Inland Wetlands Commission  
Town of Prospect, CT

Application for Inland Wetlands Permit

3. Location of Property (Road): 8 TROTTERS WAY (LOT 1)

**App #2-2025 Saint Mary LLC; property owner Paula Hakim, 8 Trotters Way** - Application for regulated activities including excavation, grading, filling, new dwelling, well, deck, and septic system within the 100 ft upland review area.

Drawing Title	Drawing No.
<p><b>PROPOSED SUBSURFACE SEWAGE DISPOSAL SYSTEM</b></p>	<p><b>SHEET 1 OF 2</b></p>

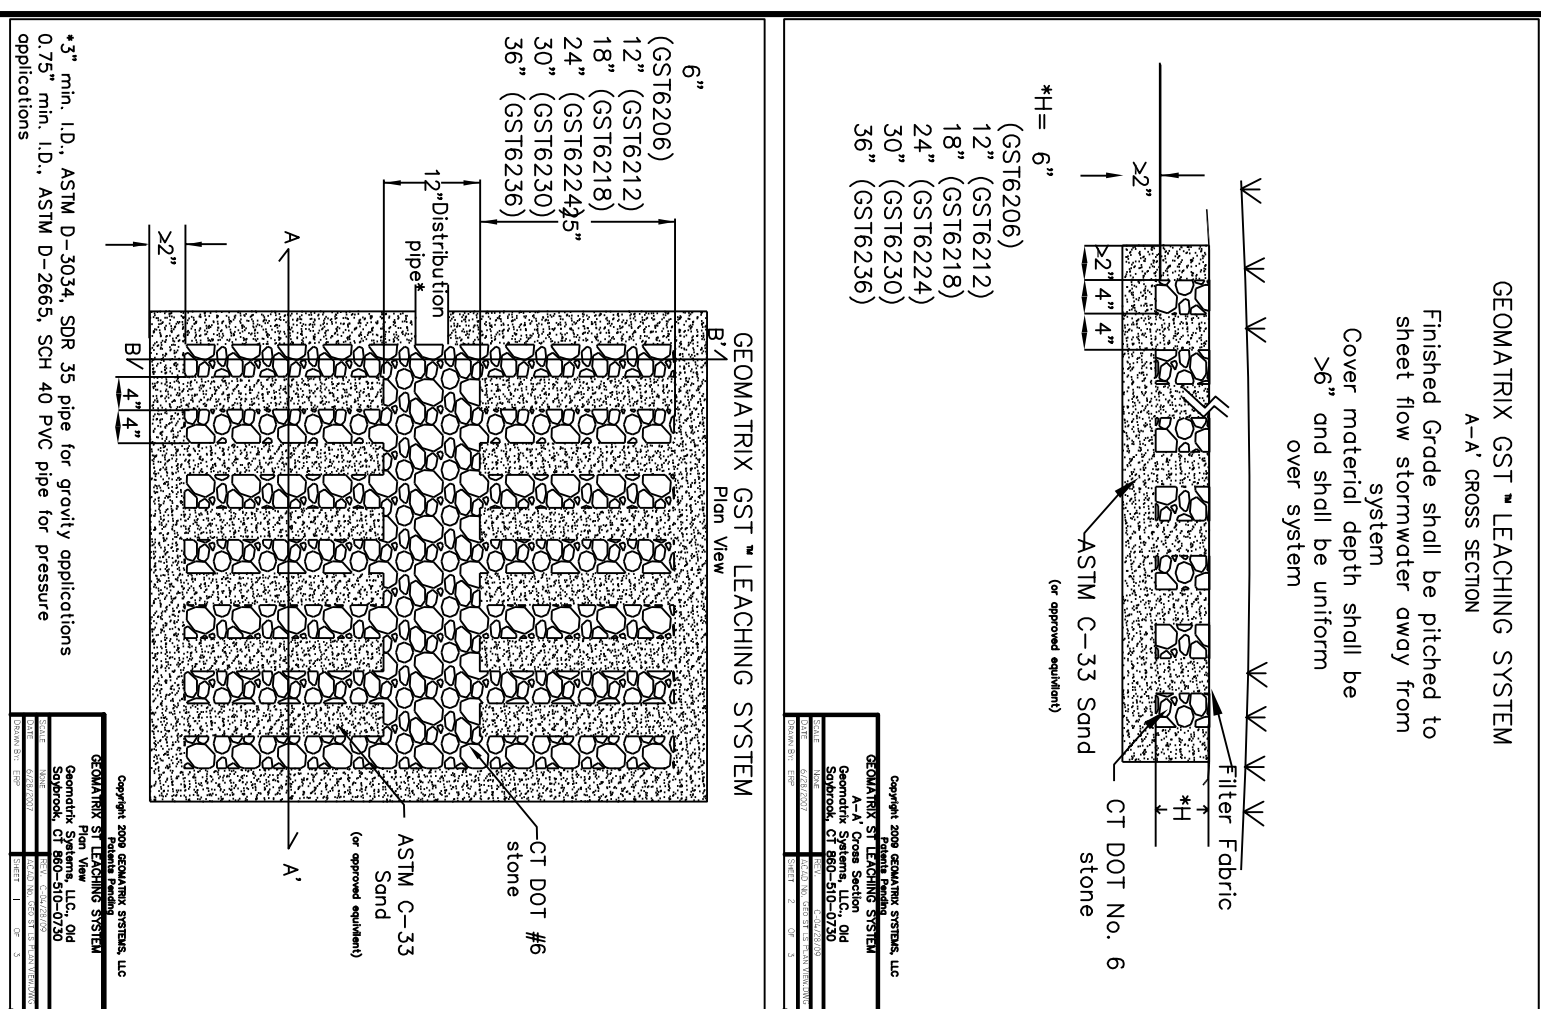
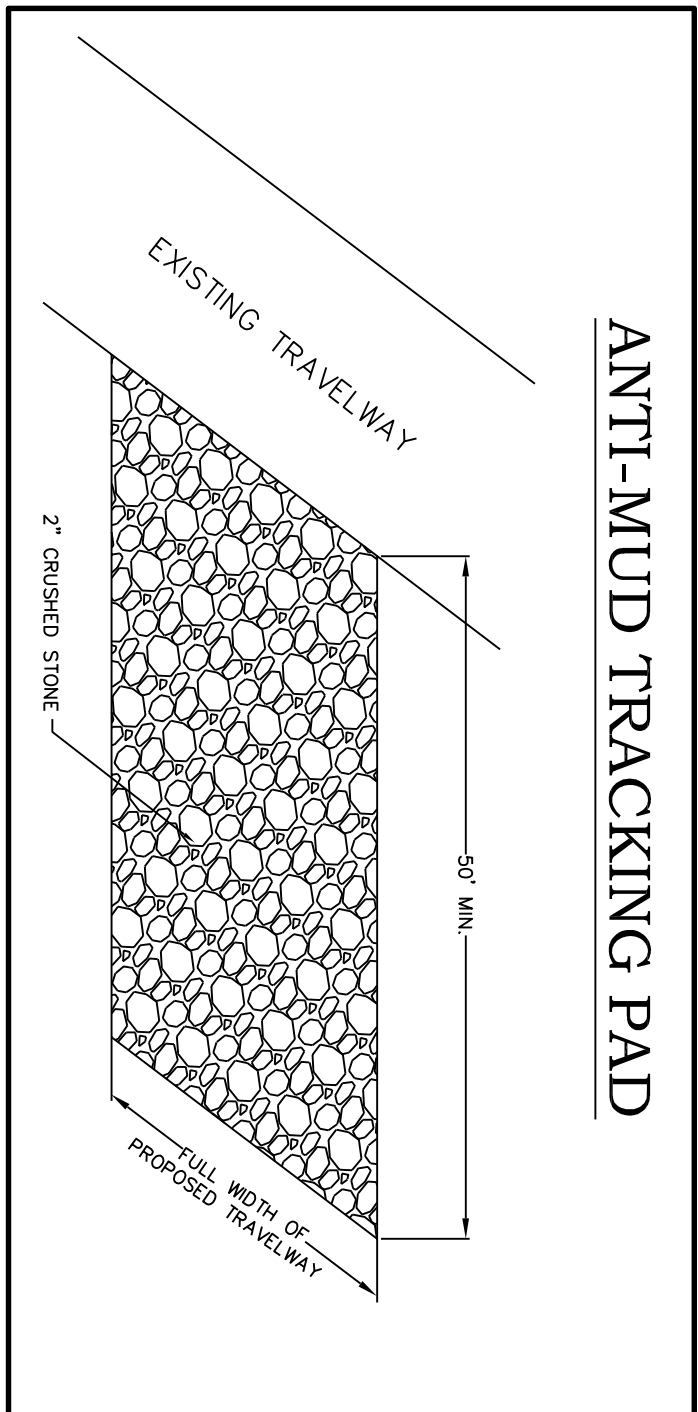
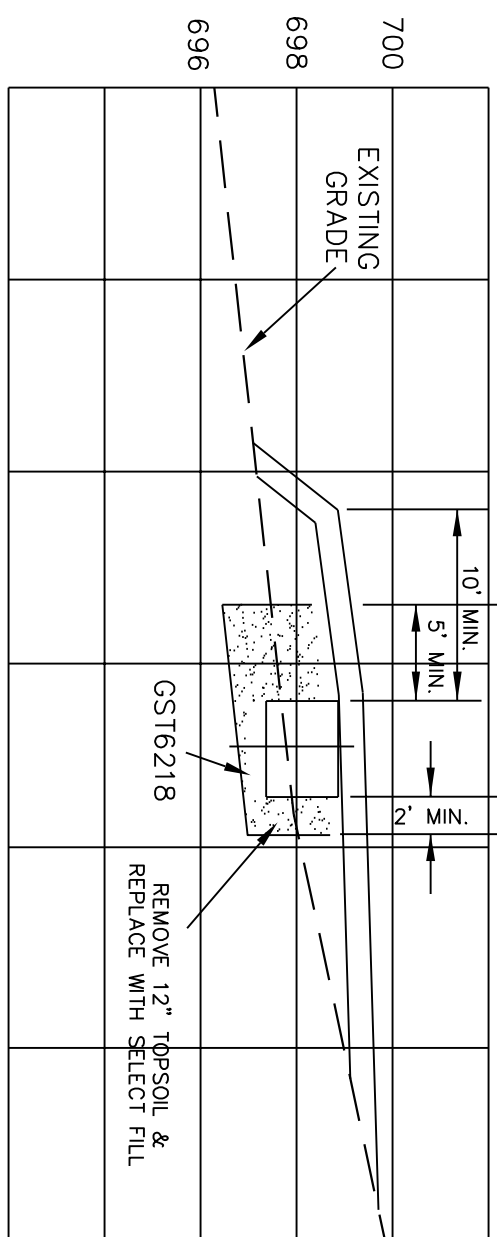
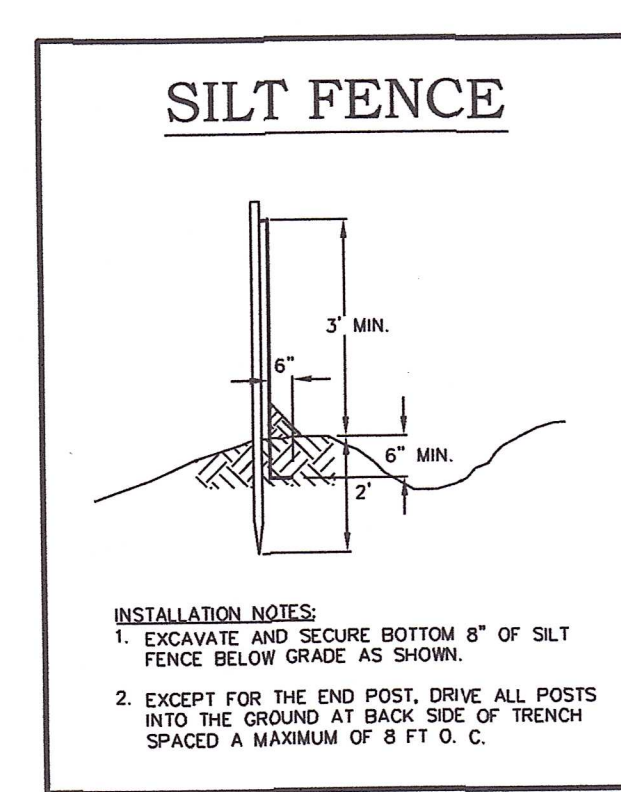
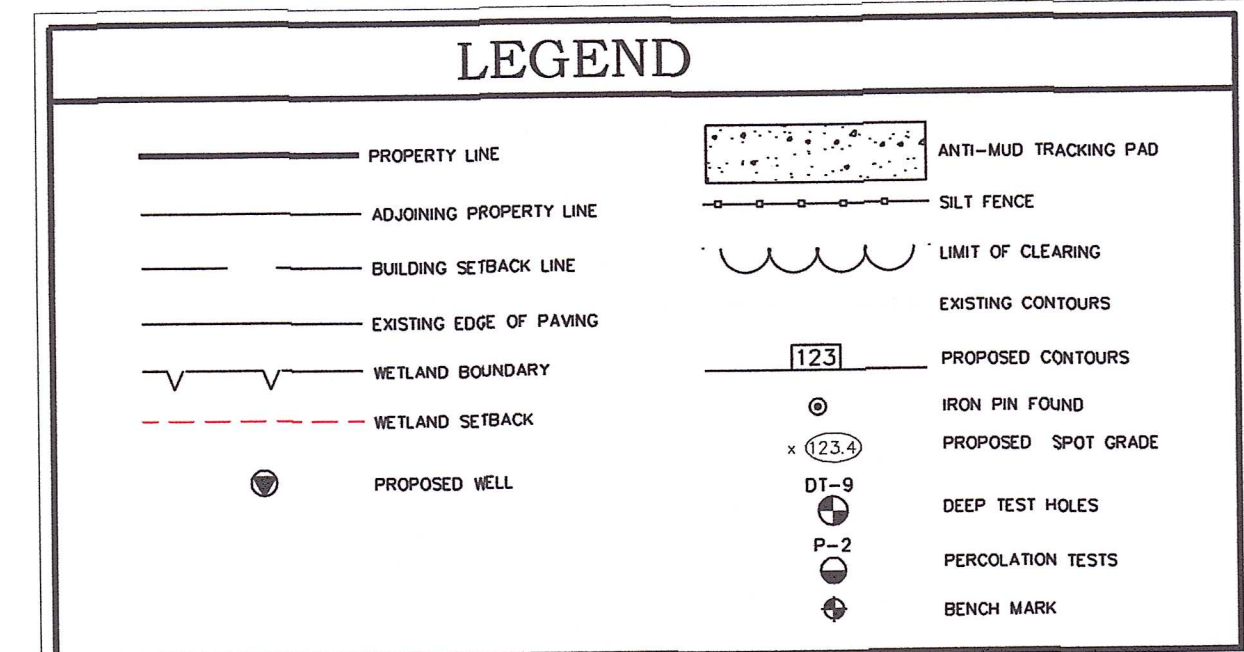
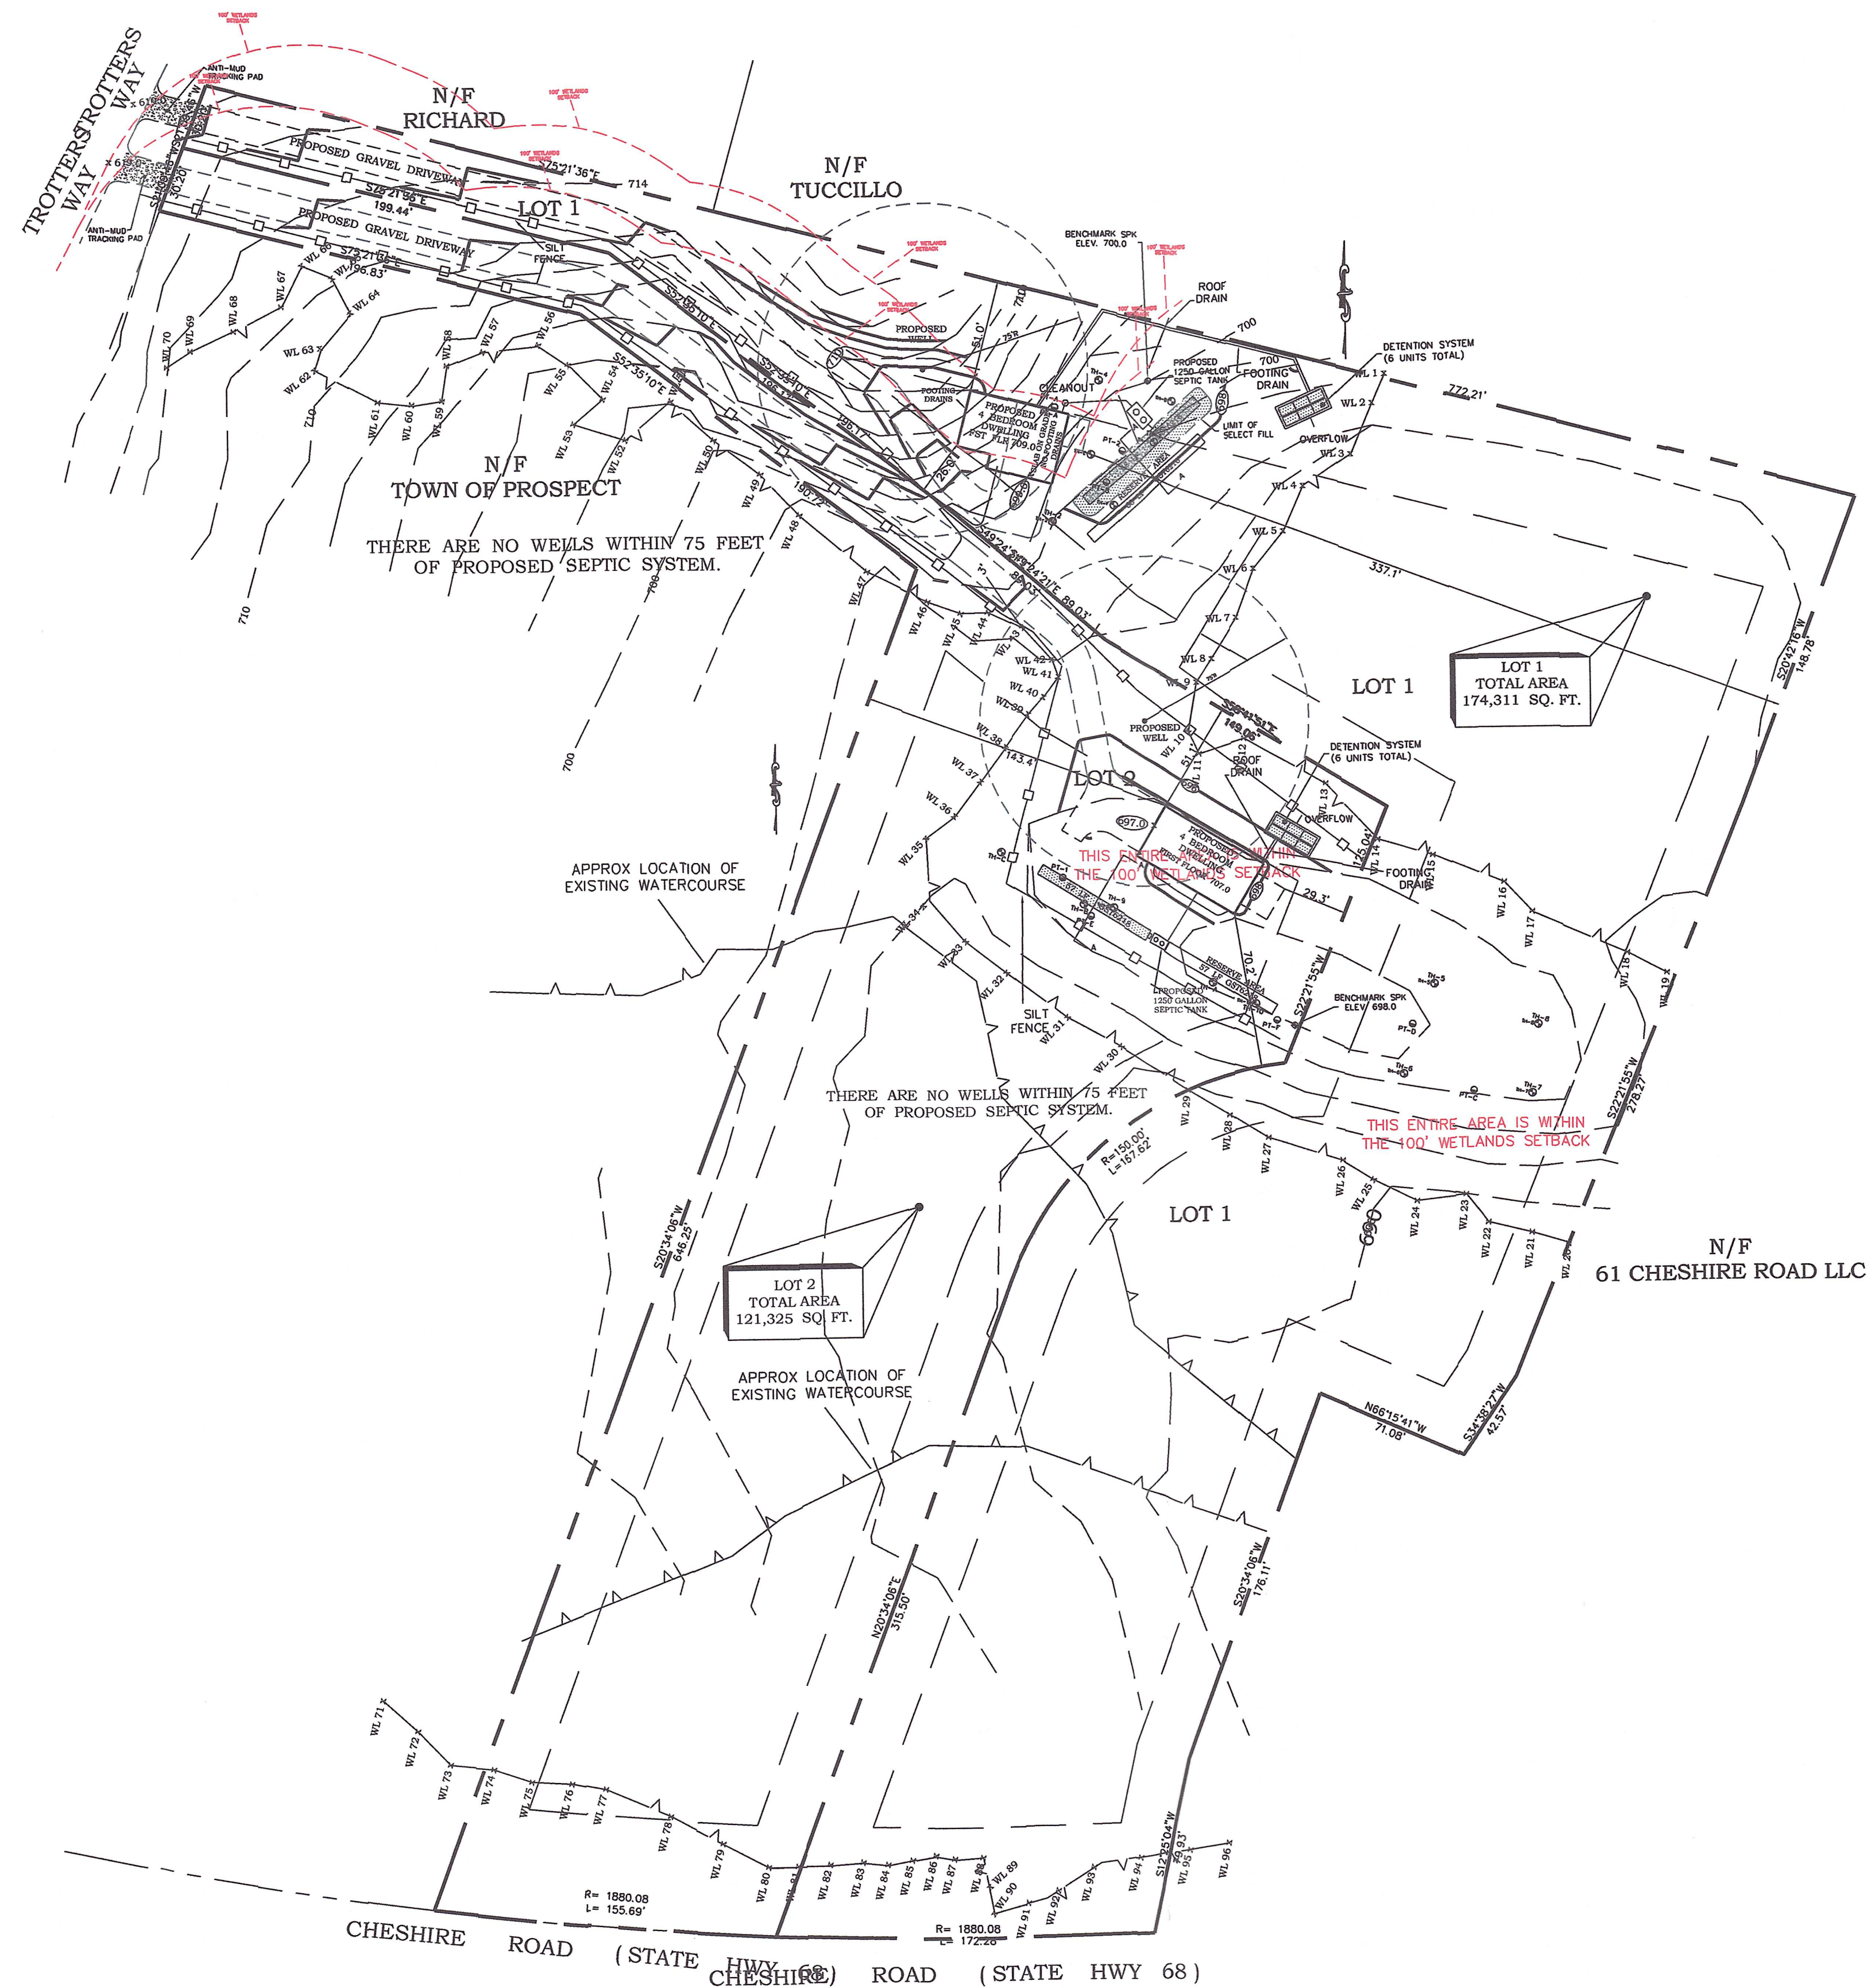
- 1) Well to be drilled and well completion report submitted to the Health District
- 2) Revised plan indicating the correct scale . Current plan is scaled to 1"=20' but noted on plan as 1"=40'
- 3) CT. Licensed septic installer completes application to construct a subsurface sewage disposal system and submits applicable fees

- 1) Well to be drilled and well completion report submitted to the Health District
- 2) Revised plan indicating the correct scale . Current plan is scaled to 1"=20' but noted on plan as 1"=40'
- 3) CT. Licensed septic installer completes application to construct a subsurface sewage disposal system and submits applicable fees

6.	6/20/2025	REVISE AS PER TOWN ENGINEER'S COMMENTS
5.	6/19/2025	REVISE AS PER TOWN ENGINEER'S COMMENTS
4.	5/15/2025	ADD CONSTRUCTION NARRATIVE
3.	5/07/2025	REVISE AS PER PROSPECT ZONING USE DEPARTMENT
2.	3/27/2025	REVISE AS PER HEALTH DEPARTMENT COMMENTS
1.	3/14/2025	REVISE AS PER HEALTH DEPARTMENT COMMENTS
No.	Date	REVISION DESCRIPTION
